ORDINANCE NO. 1963-19

AN ORDINANCE GRANTING A CERTIFICATE OF APPROVAL – WOODMONT LAND COMPANY FOR KIDDIE ACADEMY—HAWTHORN TRAILS PHASE 3, LOT 40—ROMAN DRIVE

Date: May 31, 2019
To: Donna Lobaito, Chief Administrative Officer
Village of Hawthorn Woods
From: Rolf Campbell Associates, Village Planning Consultants
Re: **Updated Review Memo Based on Revised Submissions:
Kiddie Academy – Commercial Lot 40
In the Hawthorn Trails Development
NE Quadrant Quintin Road & IL. Rt. 22**

TITLE:
CONCEPTUAL ENGINEERING PLAN

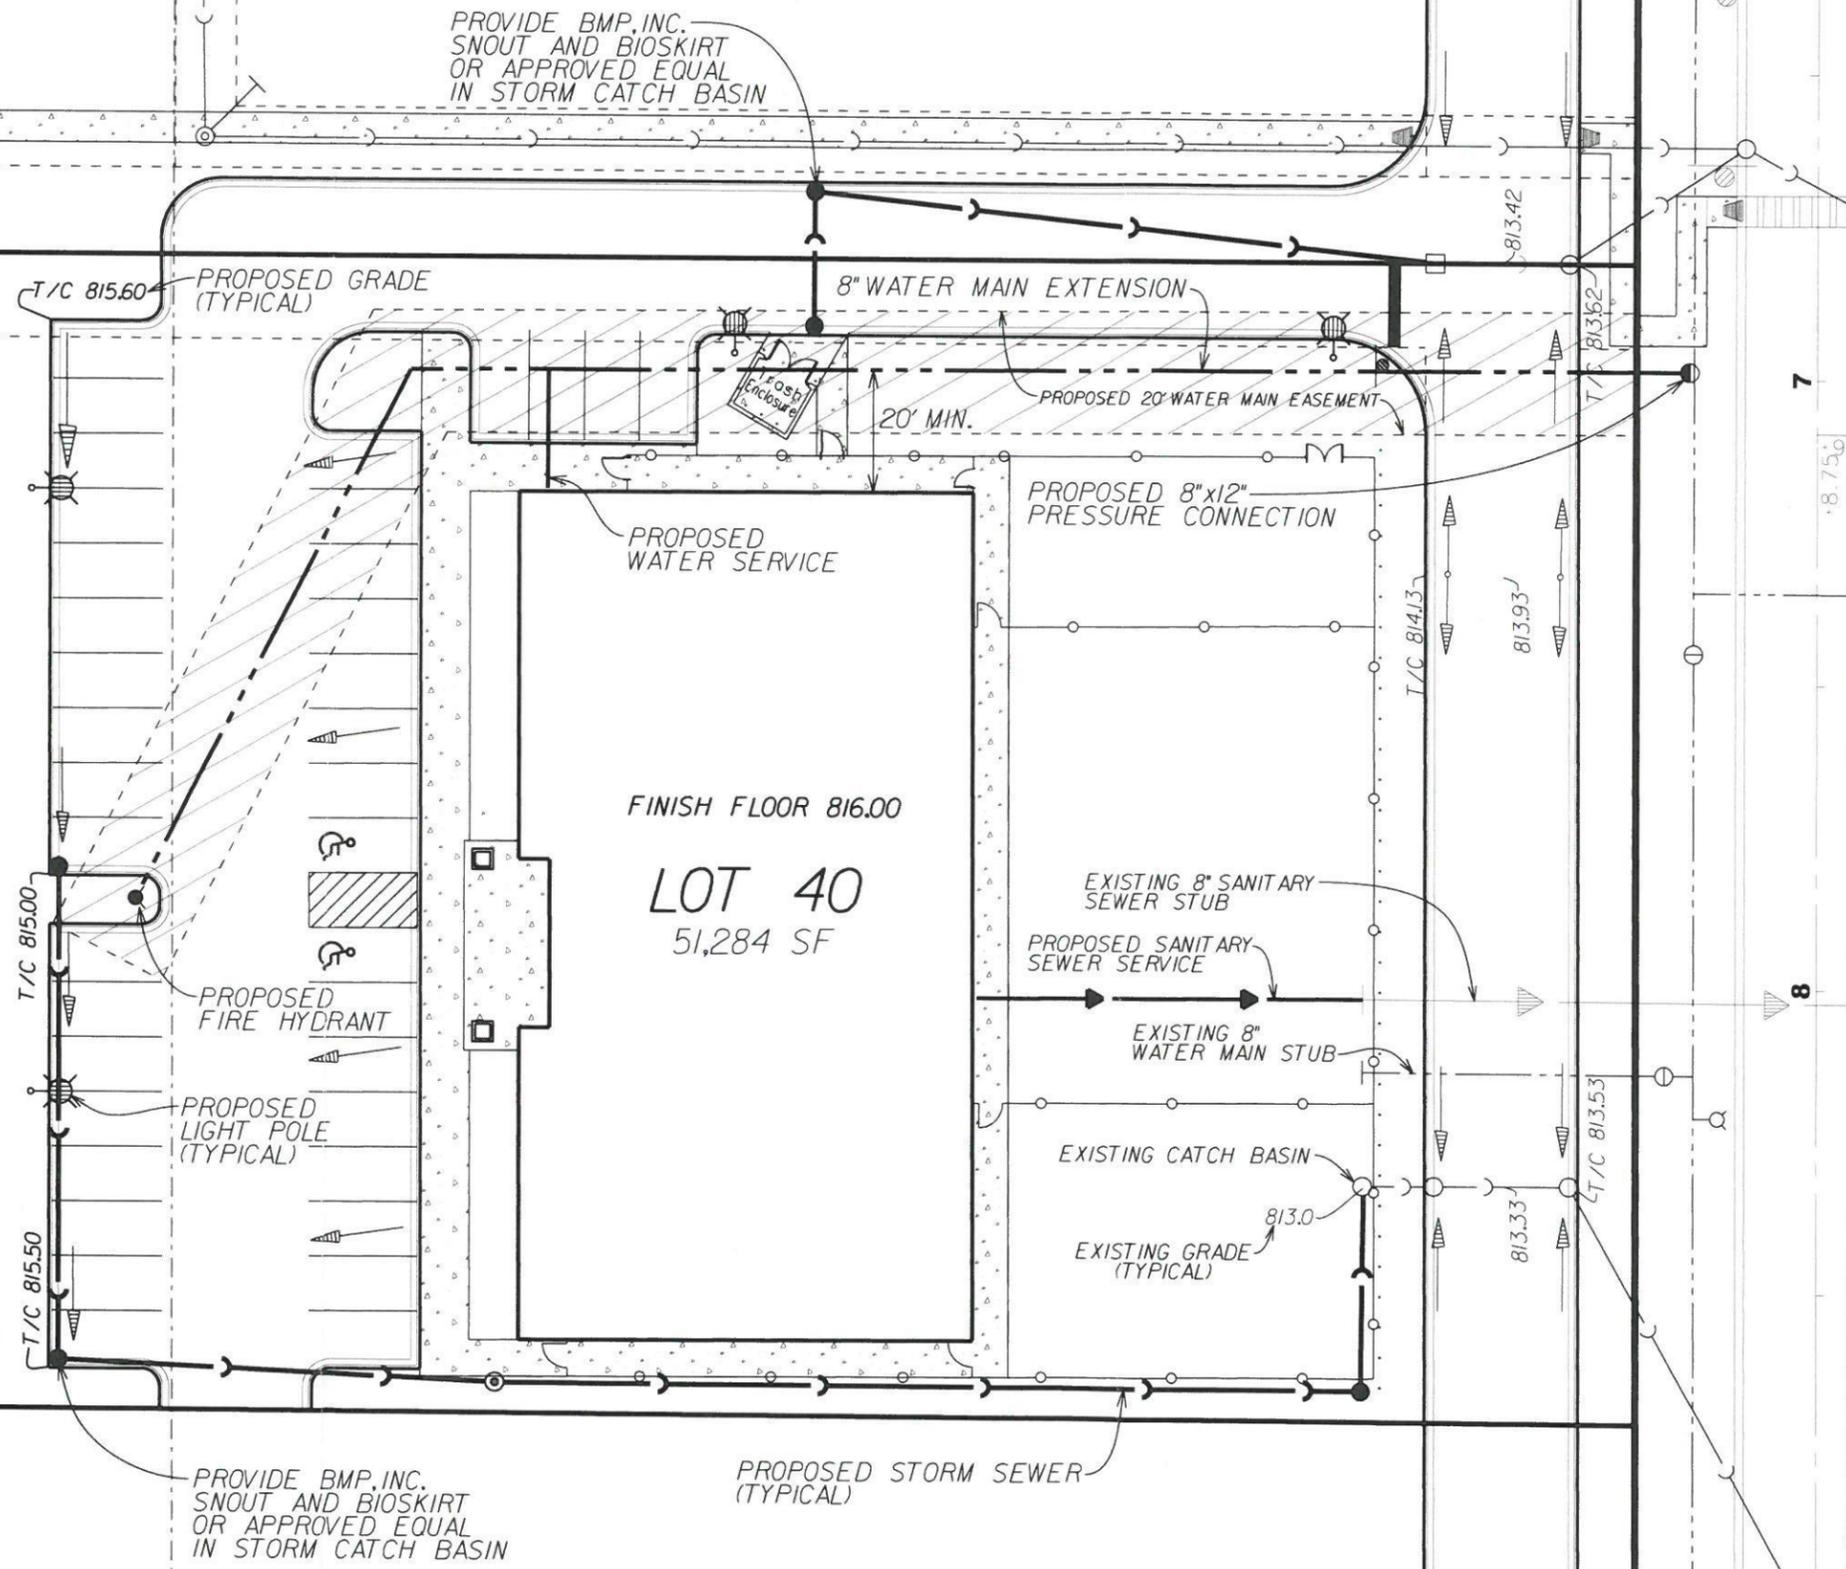
3. The plan shows a proposed fire hydrant located west of the proposed building. Aqua does not allow any private fire hydrants; therefore, the Developer would need to contact myself directly and go through the developer water main extension process with Aqua.

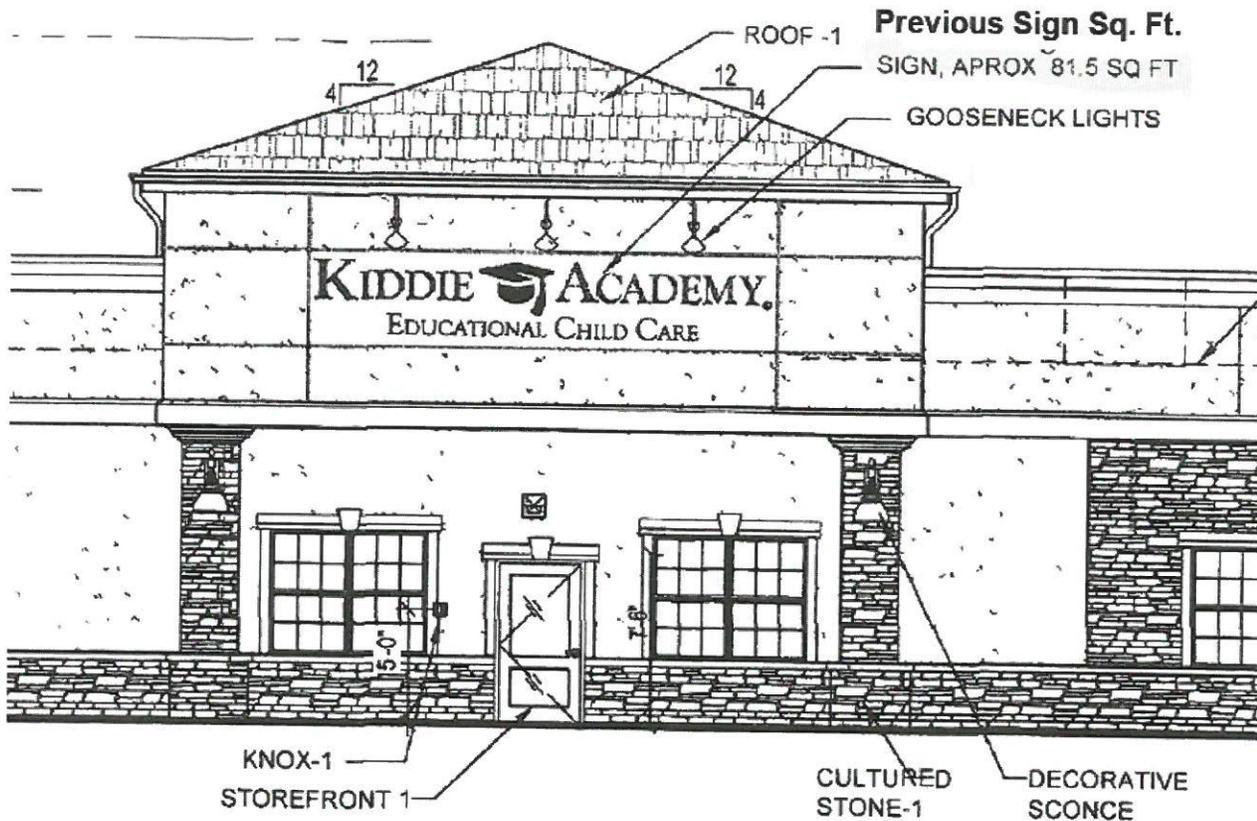
As also noted in our previous landscape review comments dated 5-6-19 at the far northeast corner of the property it appears that there were two proposed shrubs located on top of the pavement hatching. These two shrubs have been removed on the revised Landscape Plan.

**Previous Elevation Plans
from plans dated 4-11-19**

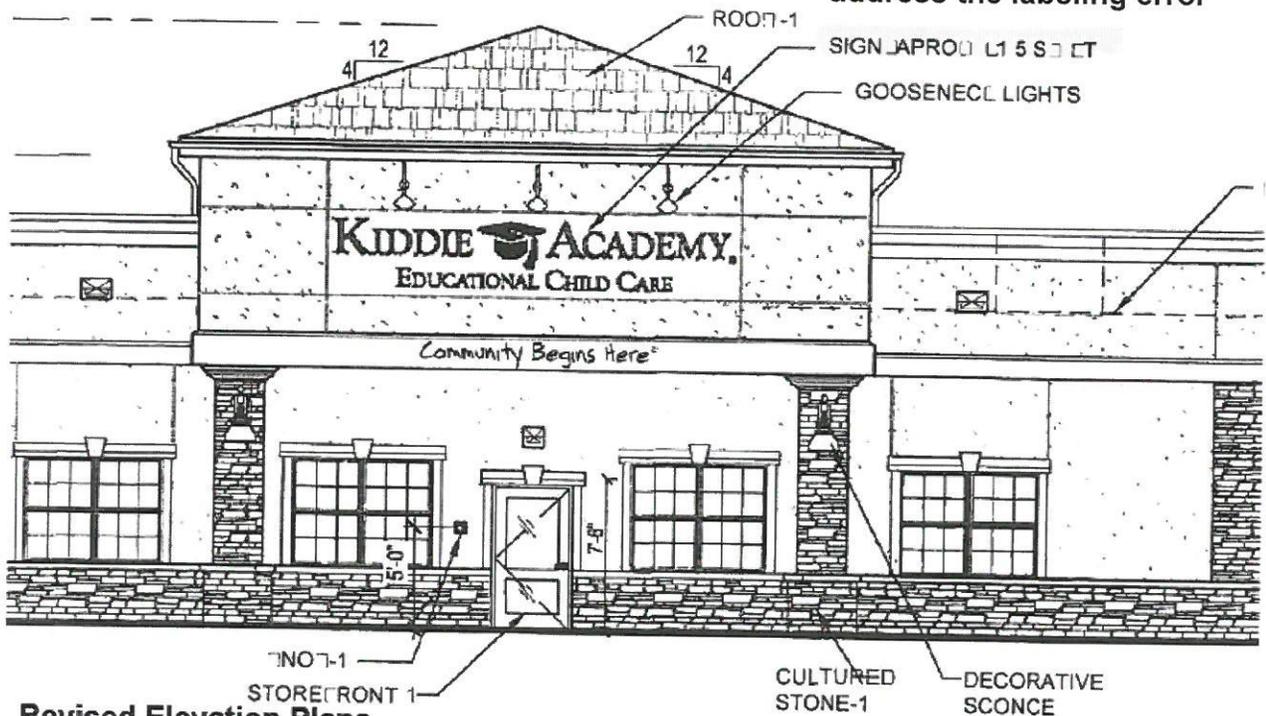
Sheet SD-1.2 “Concept Elevations.” Included with this West Elevation is a wall sign that was indicated as being approximately 81.5 square feet on the initial submission dated 4-11-19; however, on the revised submission dated 5-10-19 the label for the wall sign no longer indicates 81.5 square feet but has a label that includes symbols that appears to be in error. We are attaching an illustrative exhibit to show the comparison between the labels for the wall sign area on the two different submissions – see attached. It appears that the size of the wall sign has remained the same on both Sheets SD-1.2, and only the label for the size of the wall sign may only be in error. The Village sign regulations allows wall signs to be up to 10 percent of the area of the building wall where the wall sign is located, and the proposed wall sign does not exceed the allowed wall sign area on the front of this building facing Quentin Road.

The Applicant is requested to address the labeling error

1. The comment is posed as follows:
Sheet SD-1.2 "Concept Elevations." Included with this West Elevation is a wall sign that was indicated as being approximately 81.5 square feet on the initial submission dated 4-11-19; however, on the revised submission dated 5-10-19 the label for the wall sign no longer indicates 81.5 square feet but has a label that includes symbols that appears to be in error. ... the proposed wall sign does not exceed the allowed wall sign area on the front of this building facing Quentin Road.
